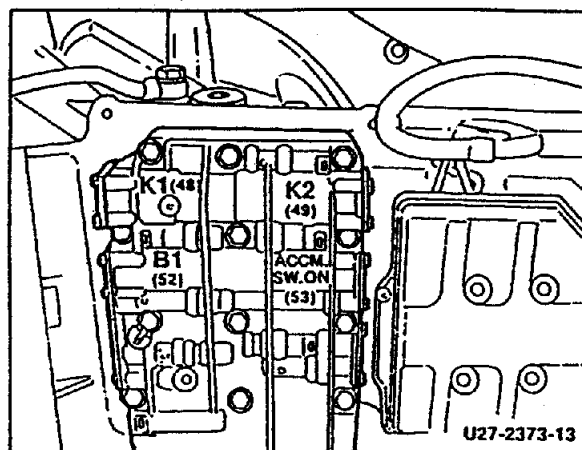
**Remedy:**  
Install modified spring kit in K1 accumulator (48) of valve body.

Part Name	Part Number
Spring kit, K1 accumulator (48)	126 270 44 77
